Landscape Review

*of the*  
**M3 Junction 9 Improvement**

*Prepared for*  
**South Downs National Park Authority**

*PINS Reference*  
**TR010055**

**FIGURE 8A**  
**Tree Removal Plan &**  
**LVIA Viewpoints**

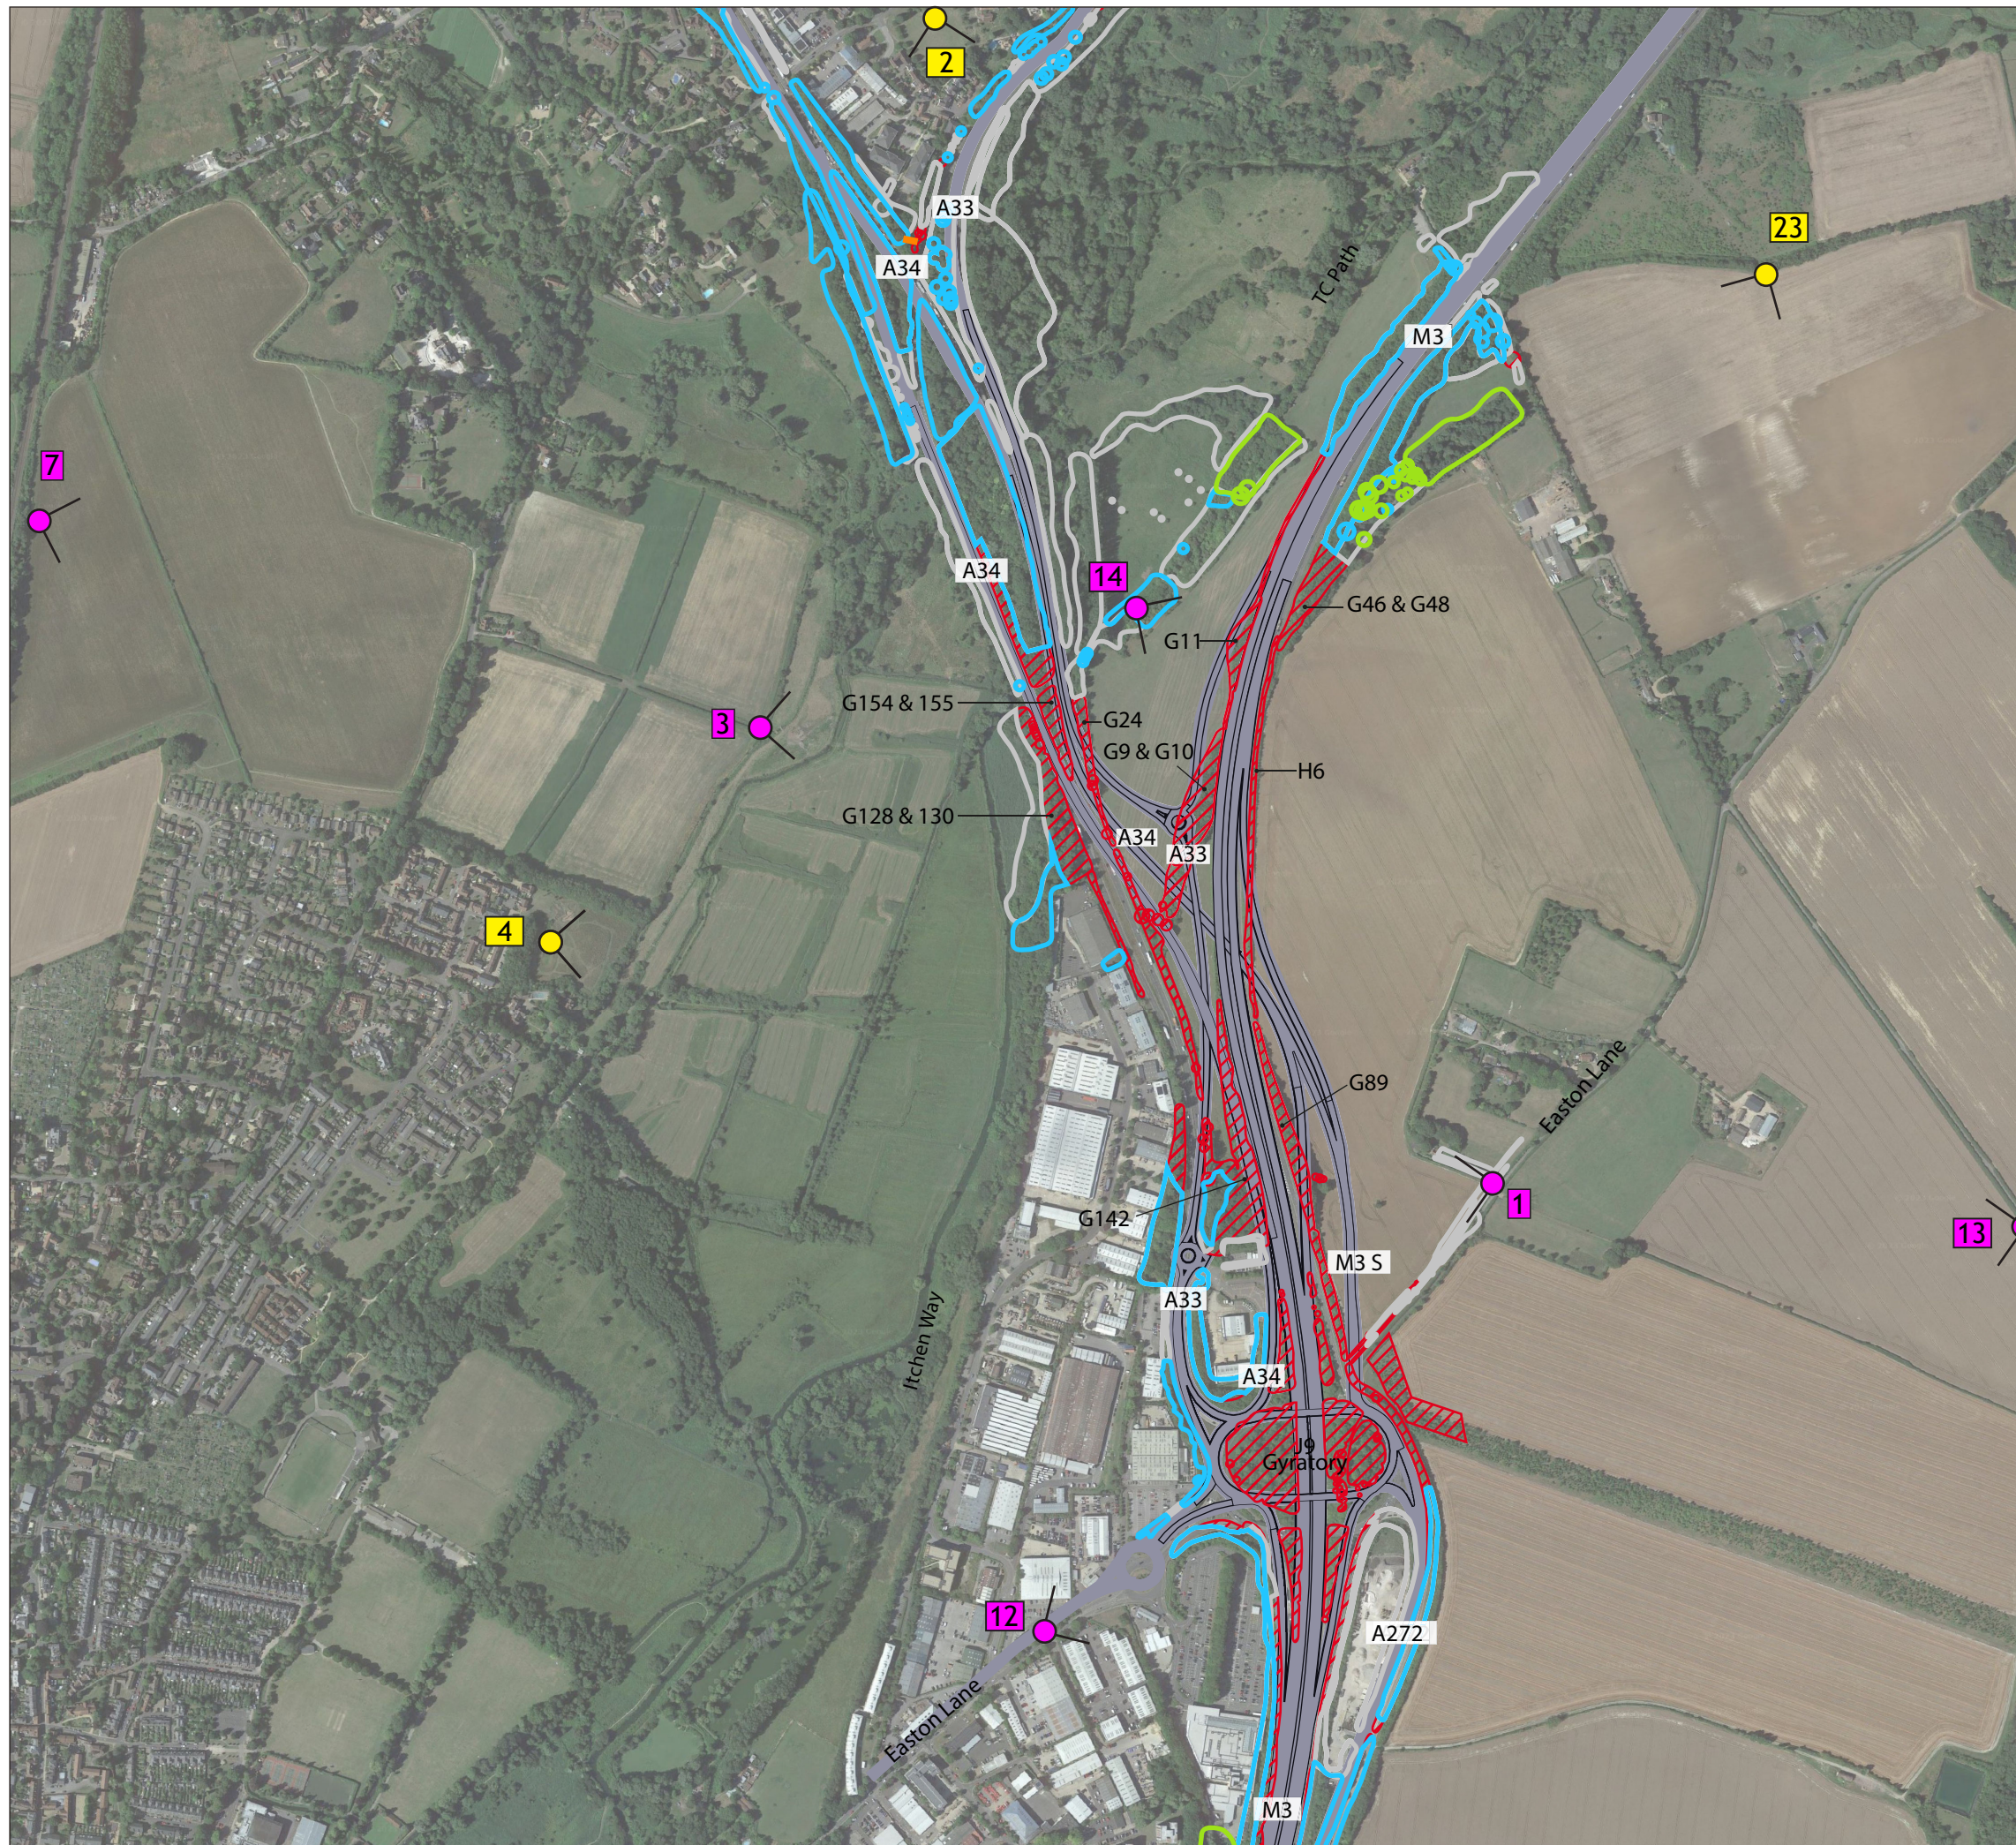
- 6.6 Drawings within NH's Arboricultural survey show the extent of vegetation which is proposed to be removed<sup>24</sup> (see red shading on **Figure 8**). These drawings show that the greatest extent of removal will occur in the landscape immediately around the existing gyratory and the landscape north of the gyratory and east of the M3 in which the bulk of the highways works are proposed. When measuring from our Figure 8, approximately nine hectares of vegetation is proposed to be removed. Virtually all existing vegetation alongside the M3 corridor will be removed. Trees along the eastern edge of the M3 currently soften the interface between the motorway and the SDNP and are relatively successful in minimising the visual impact of the motorway on the wider SDNP.

- 6.7 The tree removal includes a block of distinctive trees, including some coniferous trees which are not part of the embankment planting for the original M3 but relate to the historic field boundaries that were in place prior to the original construction of the motorway. It is identified as Tree Groups G9 and G10<sup>25</sup> on Figures 8A to this Review. It currently sits in land between the M3 and the A34. The development proposals are for four separate sections of roads in this area and a roundabout. It will not be possible to replant in this area.

- 6.8 The loss of these trees would open up views of the motorway corridor, and the new infrastructure and increased activity within it. This will be particularly noticeable from St Swithun's Way in views across the valley floor towards the valley sides and the open downland. This tree removal is not shown on the visualisations prepared by NH who have been asked to revise the visualisations. From slightly further away at Vp 7 views of both the existing motorway, the proposed infrastructure and increased activity will be opened up. Opportunities to screen this through new planting are limited.

**FIGURE 9A**  
*Environmental Masterplan & LVIA Viewpoints*

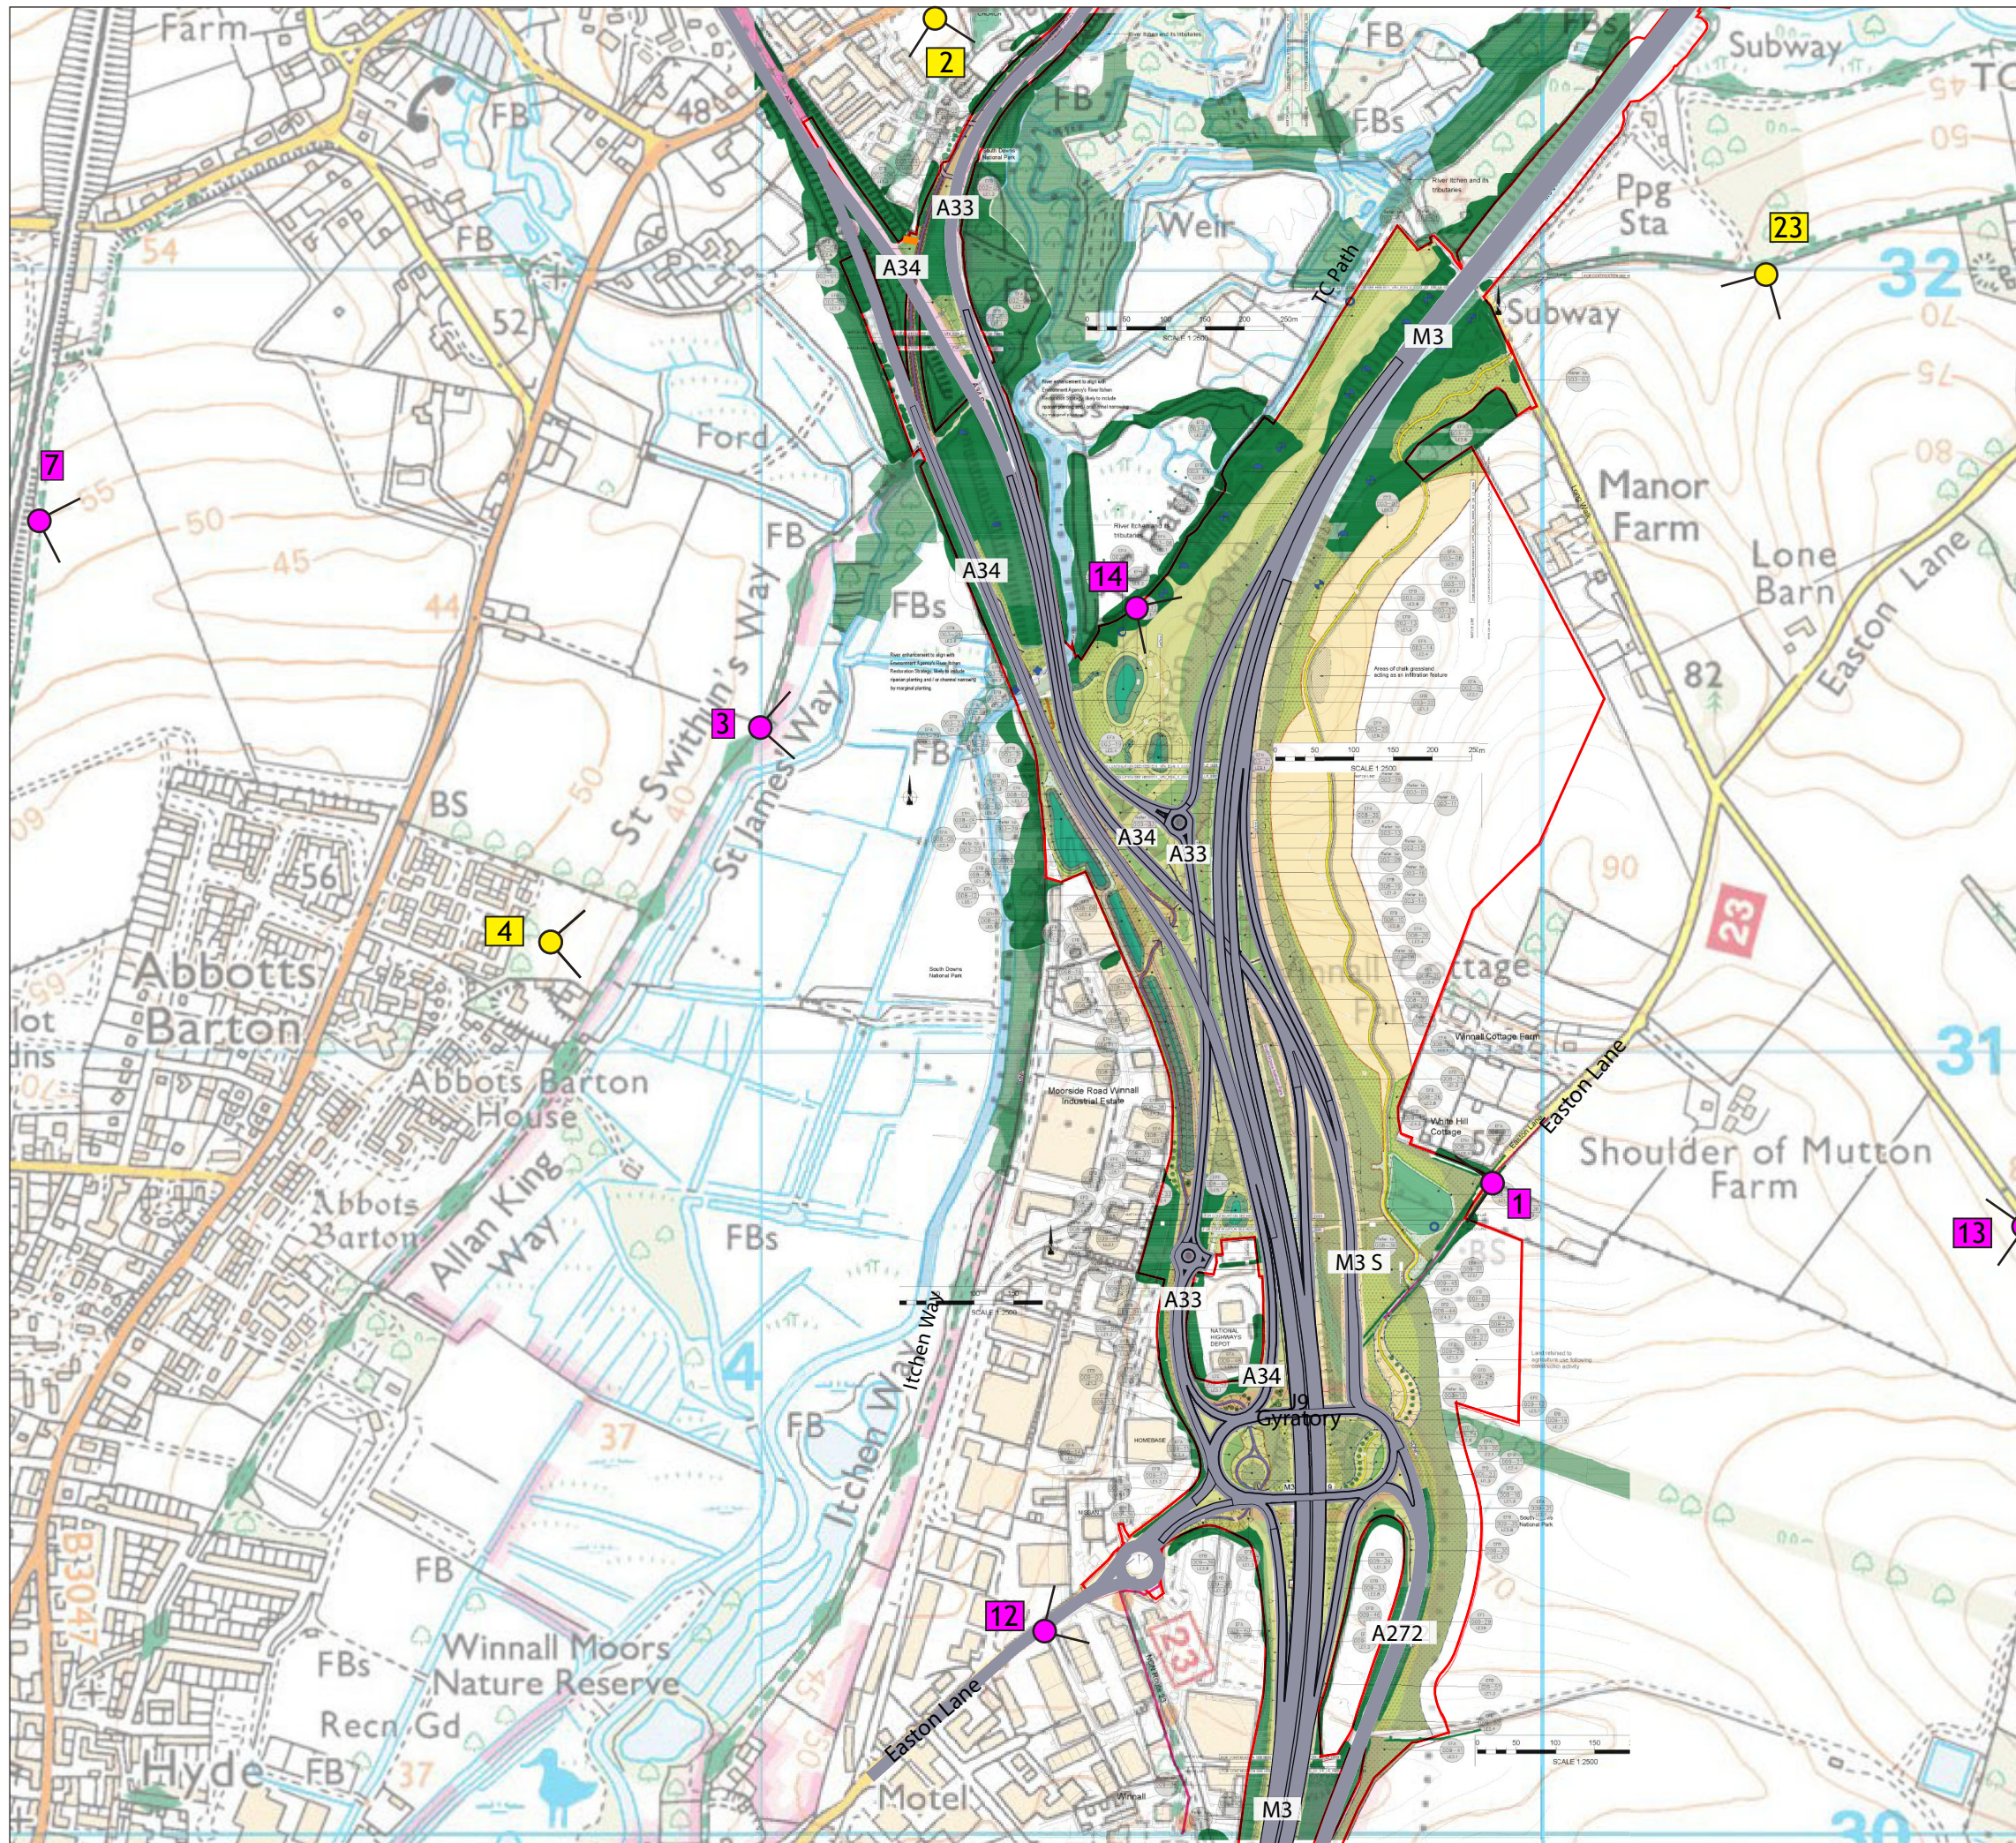
- 6.4 In addition to the long section, we also requested a shaded relief plan to show a comparison between the existing topography and the proposed topography. Currently, the proposed contours are only shown on the Environmental Masterplan (EM) (**Figure 9**) and due to the

- 6.11 In places the width of proposed tree planting alongside the eastern edge of the M3 is only 10m wide which is unlikely to be sufficient to provide a robust level of screening of the road infrastructure and activity, particularly in the short term, for people within the SDNP e.g., Easton Lane, Long Walk, and the proposed bridleway between these lanes. In some areas, the proposed tree planting is narrower than the existing level of tree cover that would be removed, which is up to 25m in width (**Figure 9**). Further, in some areas the majority of the proposed planting is located on the cut batter rather than above the slope, where it would be more effective at providing visual relief in views from higher ground east within the SDNP. We recommend that as a design principle, tree planting along the eastern edge of the motorway is no less than 25m in width and that at least half of this planting occurs on top of the cut batter where it will be more elevated and will provide more effective screening. This will encroach on the chalk grassland which, as discussed in Section 8 below, should be extended to the east.

- 7.1 The proposals include an approximately 875m long swale alongside the proposed bridleway between Easton Ln and Long Walk, and an attenuation pond at the south eastern end of the site (**Figure 9**). The attenuation pond would be located immediately alongside the proposed bridleway. It would be visible from the bridleway as well as from Easton Lane. The swale and pond would be located east of the M3 within the open downland landscape type. These features would be incongruous within the chalk downland landscape which is otherwise characterised by large open arable fields over rolling downs and dry valley systems. The swale and attenuation pond, and the associated earthworks required to form the pond, would not read as part of the downland landscape but as part of the overall highways landscape, which would be perceived as having extended into the downland. Loss of the open download character would be exacerbated by proposals to enclose the pond at the south eastern end of the site with scrub and woodland planting - the type of planting which is currently largely restricted to the lower valley sides and valley floor. These features would neither conserve nor enhance the natural beauty and character of the SDNP in a location where there is significant interaction between the public, the SDNP and the scheme.

- 7.2 There are no plans which show the proposed contours for the attenuation pond. Neither its proposed depth, nor the steepness of its slopes. However, with a footprint of approximately 4,200m<sup>2</sup>, it would be seen as a large engineering feature in the landscape. Further information should be provided by NH explaining the detailed design of the attenuation feature and the swale, and the measures taken to ensure that any potential environmental benefits of these features have been maximised.

amount of information on the EM, they are difficult to read. A shaded relief plan will be the easiest way for the Examining Authority to understand the proposed changes in level and should be provided by NH.
